PROOF OF EVIDENCE

land at Teversham Road Fulbourn

LPA Reference: S/3290/19/RM

PINS Reference: APP/W0530/W/22/3291523

Fig 2.3.1 Proposed Attenuation Catchment B with flow control highlighted

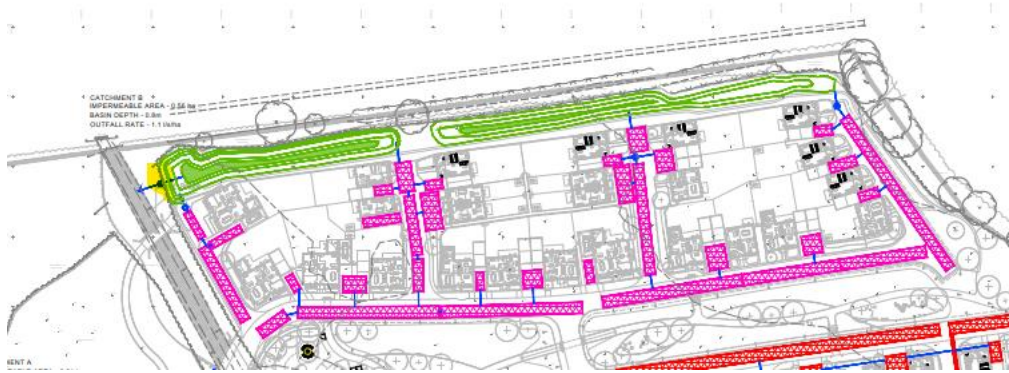
2.3 Flow control for Catchment B appears to be done by one device, it is not clear at what level the crates are or how surface water will be restricted from these or surcharge back to them. The crates on the road adjacent to the bridge structure in particular appear to be at a higher level than the cover level of the flow control manhole and bio-retention basins maximum water level. Catchment B is shown in Figure 2.3.1 below.

Fig 2.4.1 Design Surface water flood plot with abrupt development retaining structure highlighted

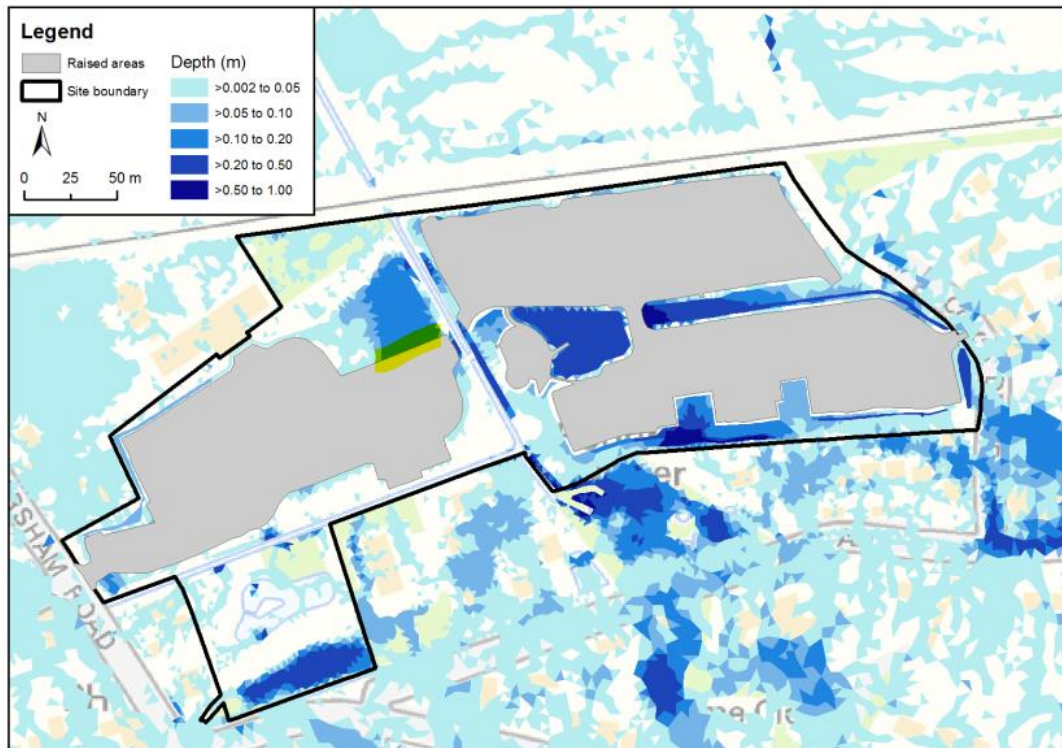
2.4 A proposed spot level diagram has been provided, however there are not many values in some of the areas proposed for surface water storage. Given that in some of the modelling plots surface water seems to pool at a depth against a retaining structure as shown in Fig 2.4.1 below it is not clear that embankments to achieve access to lower levels of the site have been modelled.

Fig 3.6.1 Impermeable area plot provided with hydraulic modelling.

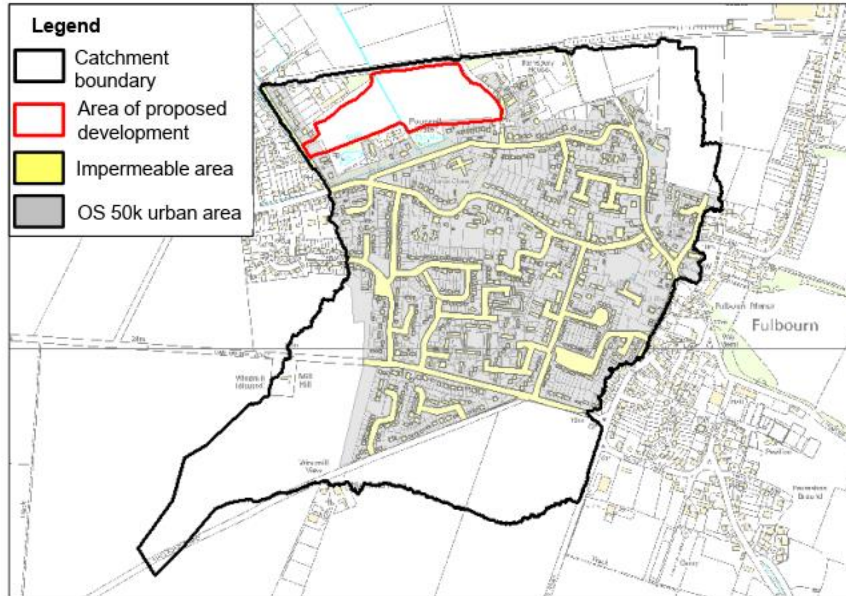
- 3.6 The calculation of impermeable area within the modelling appears only to include roofs and roads, not paved or car parking areas. This appears to be an under representation of impermeable areas as lots of properties in the catchment have paved areas between the street and the house that are not represented as impermeable in the model.
